### **ISLAND LAKE NORTH BAY TREE REMOVALS JSP21-23**

Matter of Consideration at the request of Elliott Milstein, President of Island Lake North Bay Homeowner's Association, for approval of a Revised Landscape Plan. The subject property contains 22.1 acres and is located in Section 18 & 19, east of Napier Road, north of Seaglen Drive. In this revised request, the applicant is proposing to remove 37 landscape trees within open space common area of the Island Lake North Bay Homeowner's Association (Phase 6 of Island Lake) due to tree health, site congestion, and aesthetics.

**PLAN REVIEW CENTER REPORT**  
**Planning Review**  
**ISLAND LAKE NORTH BAY TREE REMOVALS – 1<sup>st</sup> Revision**  
JSP 21-23  
October 1, 2021

**PLAN REVIEW CENTER REPORT**  
**October 1, 2021**  
**Island Lake North Bay Condos Tree Removals**  
**Revised Landscape Plan Review**

© 2001 Tree Group, Inc.

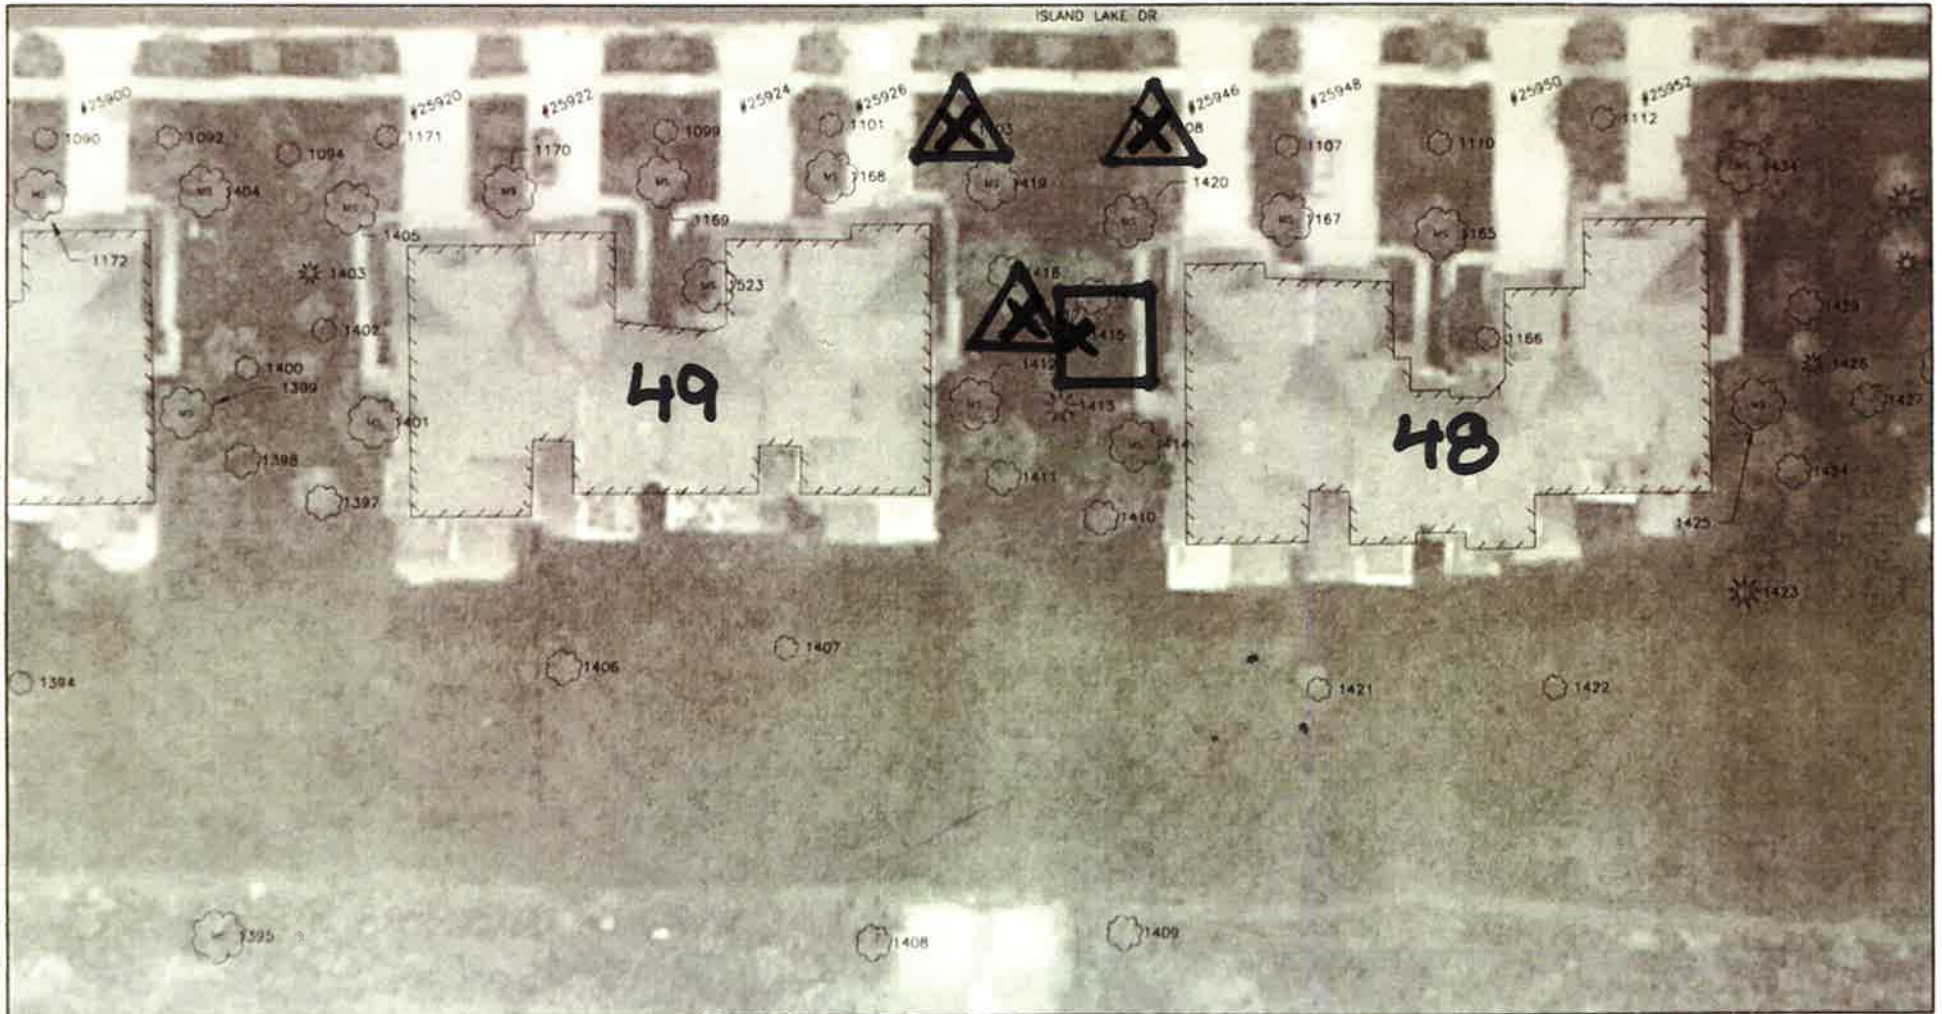
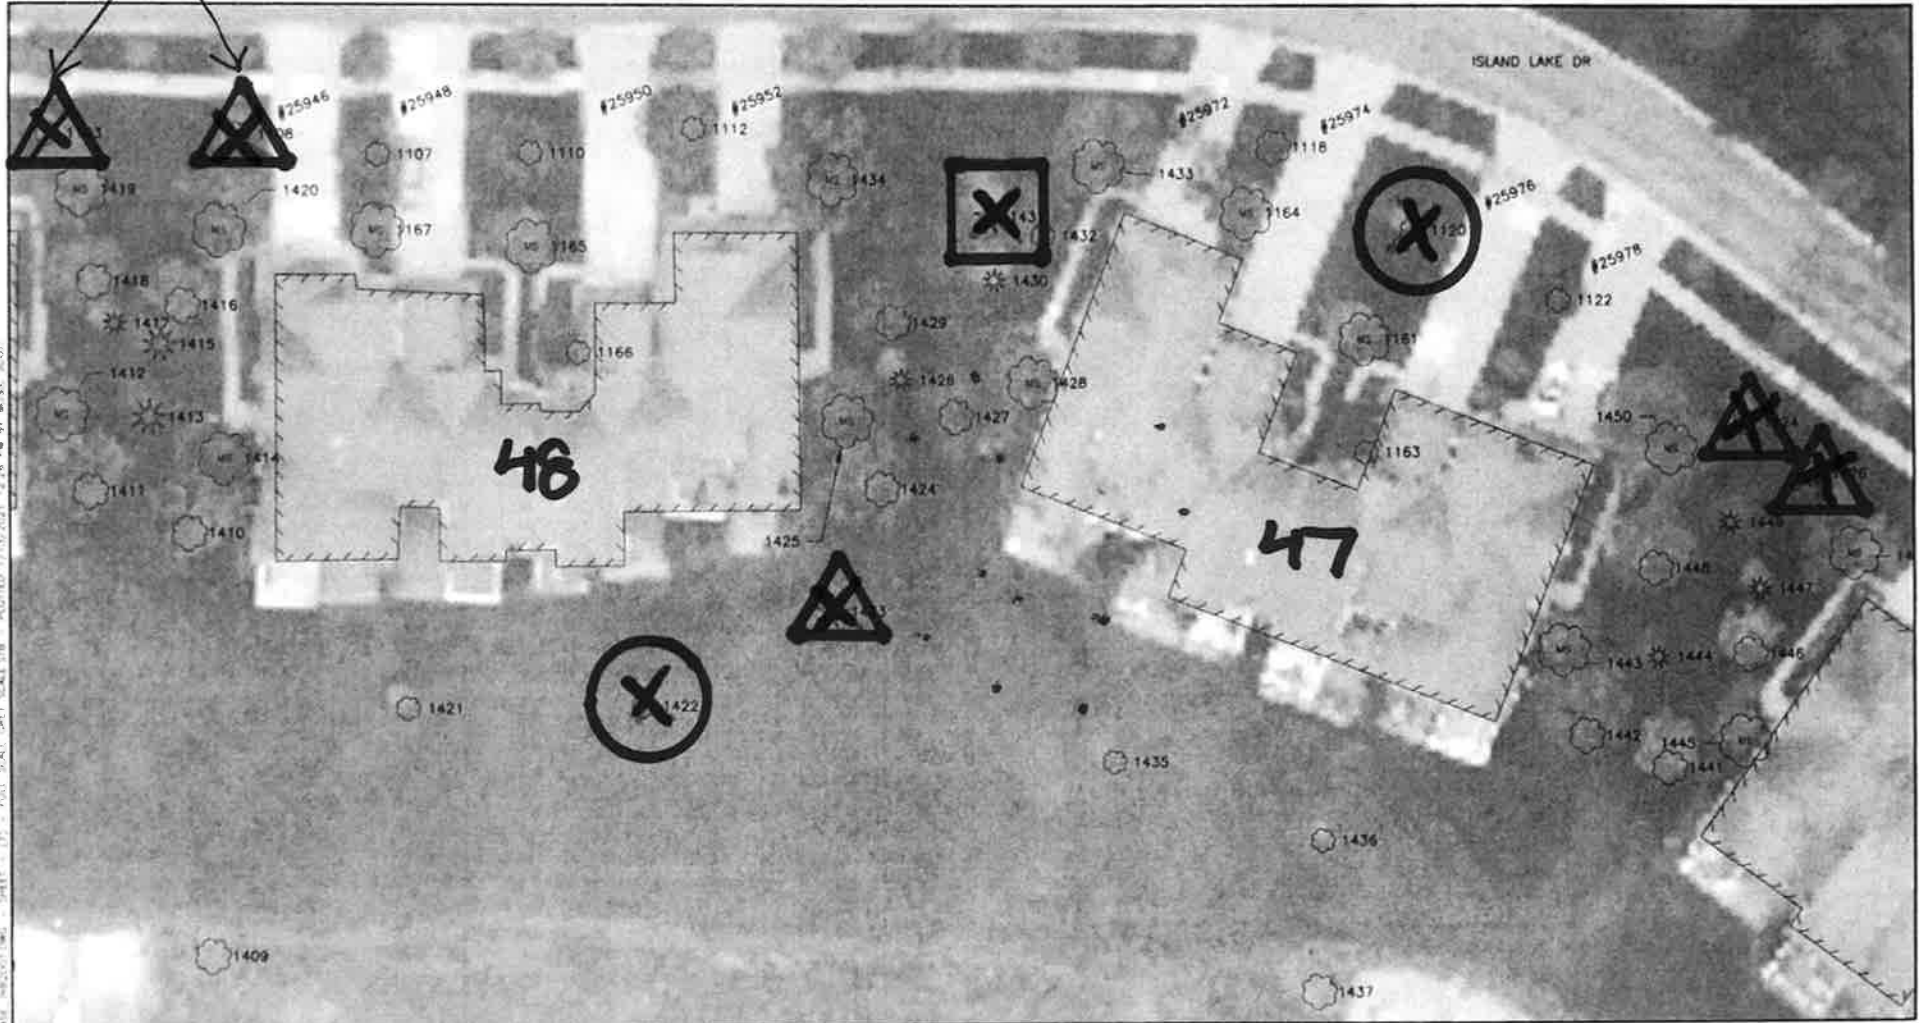
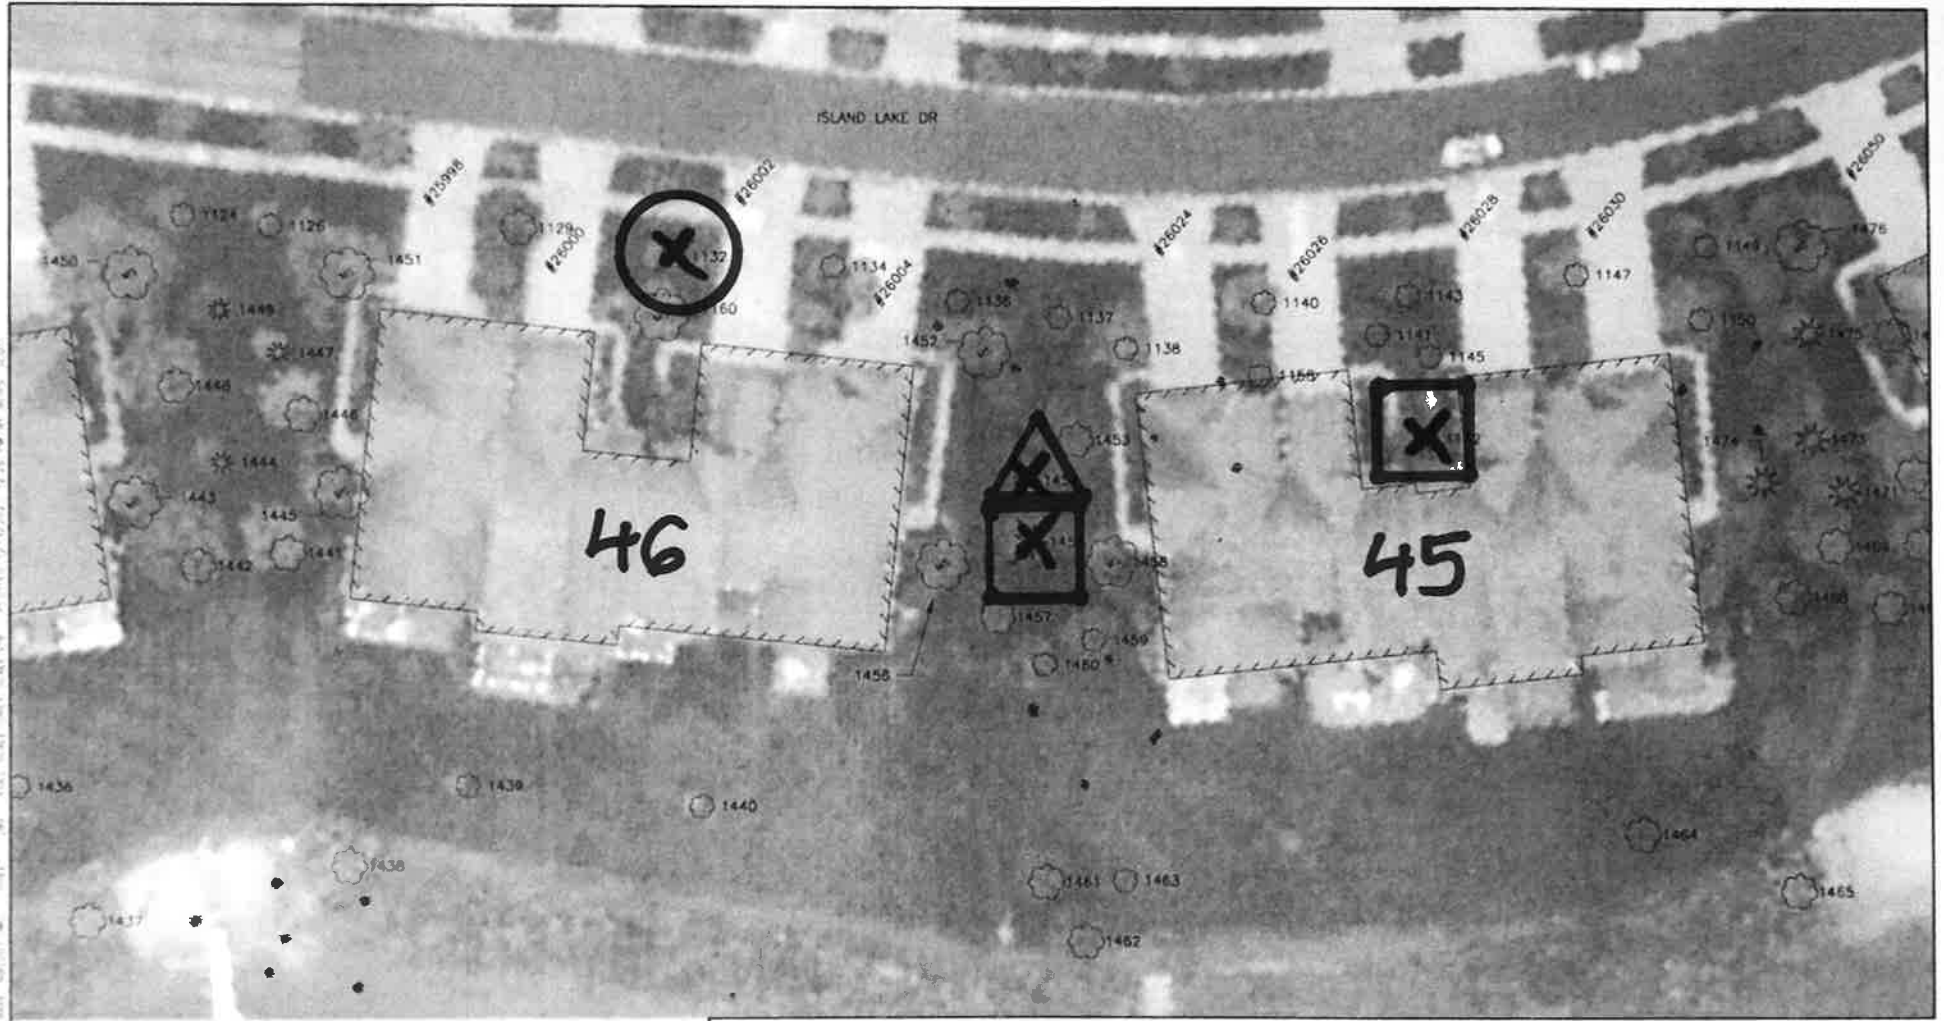
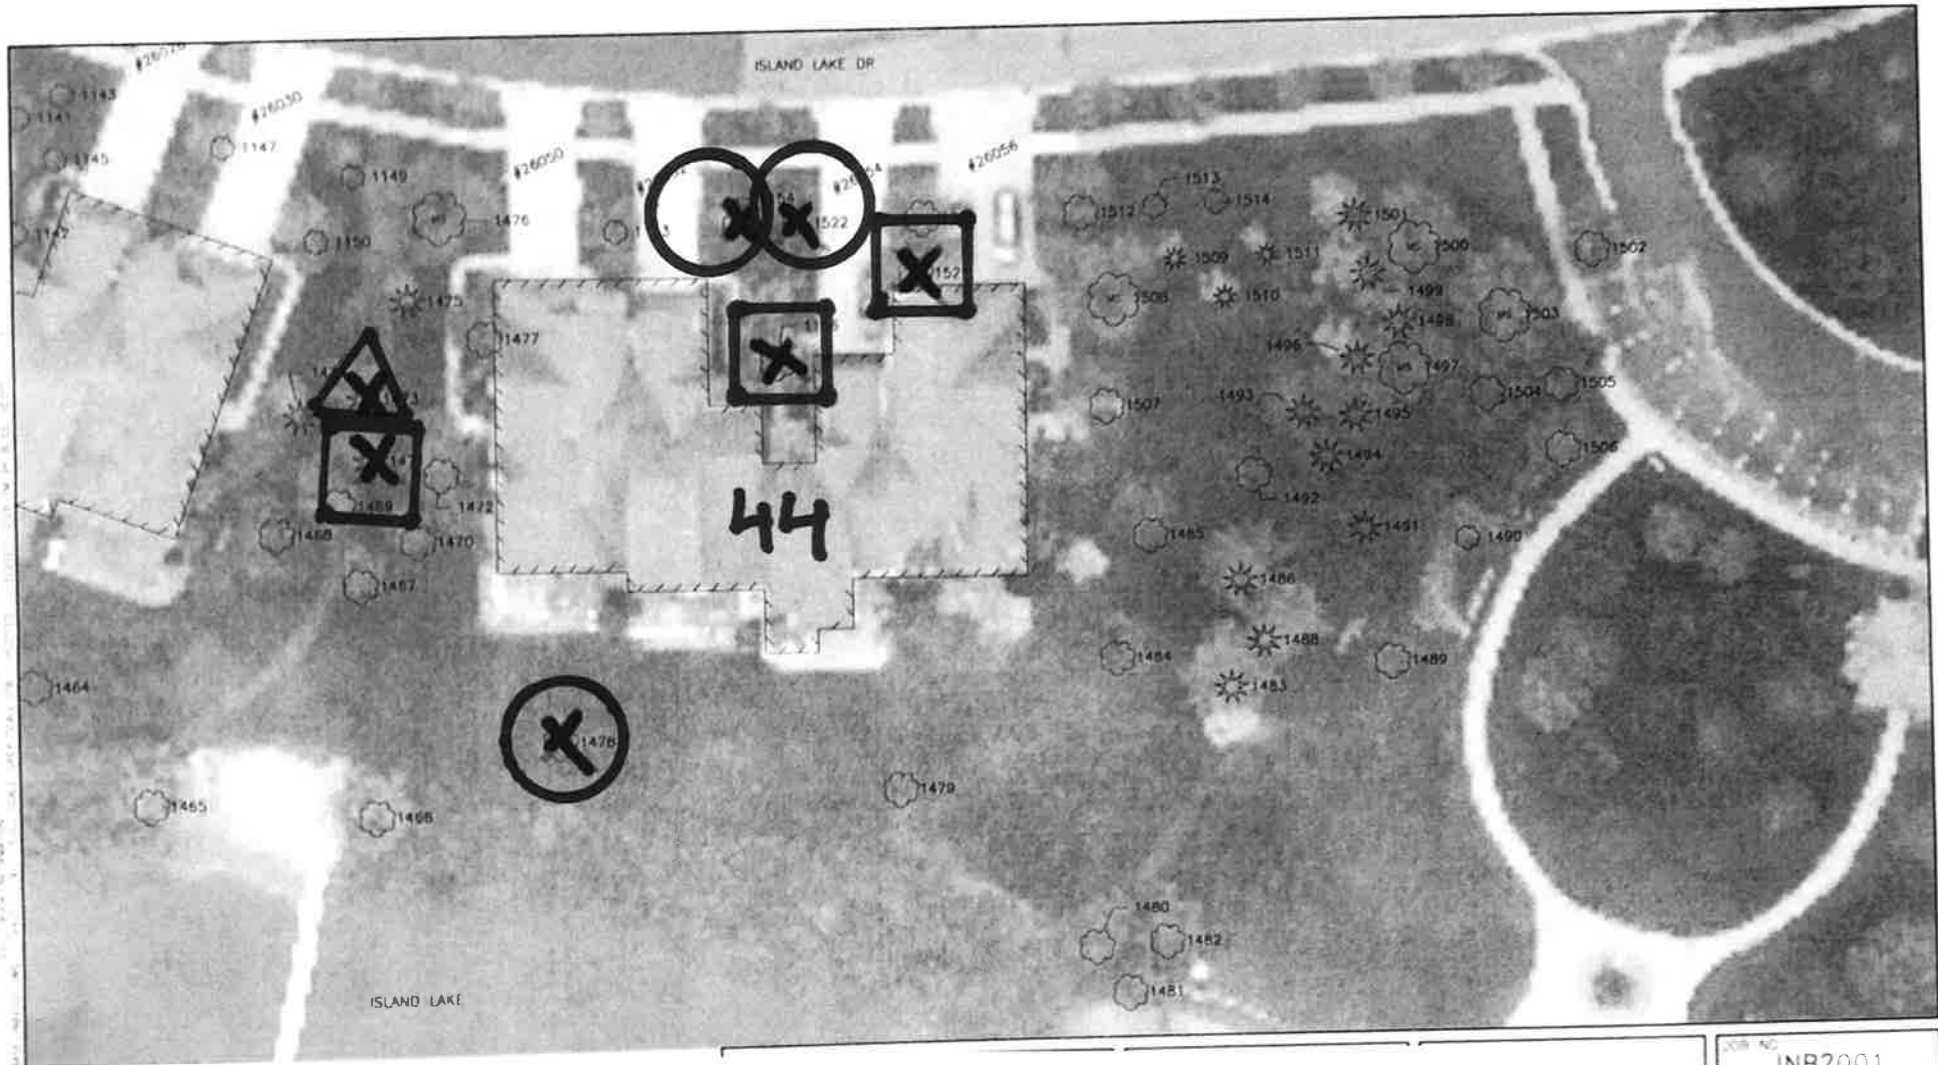
- CIRCLE:** Trees not shown on any plan, may be removed without replacement 15 trees
- TRIANGLE:** Trees on a plan that staff recommends for removal without replacement 14 trees
- SQUARE:** Trees on a plan that staff does not recommend for removal without replacement 8 trees

Staff's recommendation is to (1) allow the applicant to remove 29 trees without replacement, and (2) either don't allow removal of the remaining 8 trees, or, if the Commission does allow those 8 to be removed, to require replacement. (To be more specific, only 7 of these 8 trees are technically proposed for removal. One of the 8 is already missing, and therefore staff is recommending it be replaced.)

- **15 trees not on any plan—allow with no replacement.**

All trees <b>not</b> on a plan approved for removal without replacement:	15 trees
Trees on a plan that staff supports removing without replacement:	
• Between Units 57 and 58:	1 tree
• Between Units 56 and 57:	1 tree
• Near street between Units 55 and 56:	1 tree
• Near street between Units 54 and 55:	1 tree
• Between Units 50 and 51:	1 tree
• Near street between Units 51 and 52:	1 tree
• Near street between Units 48 and 49:	2 trees
• Between Units 48 and 49:	1 tree
• Between Units 47 and 48 (on lake side):	1 tree
• Near street between Units 46 and 47:	2 trees
• Between Units 45 and 46	1 tree
• <u>Between Units 45 and 45</u>	<u>1 tree</u>
	14 trees

**As mentioned above, there is 1 shoreline tree behind Unit 55 that has been removed but was not included in the proposal. That tree should be replaced as it was on the shoreline plan and serves important aesthetic and ecological function.**
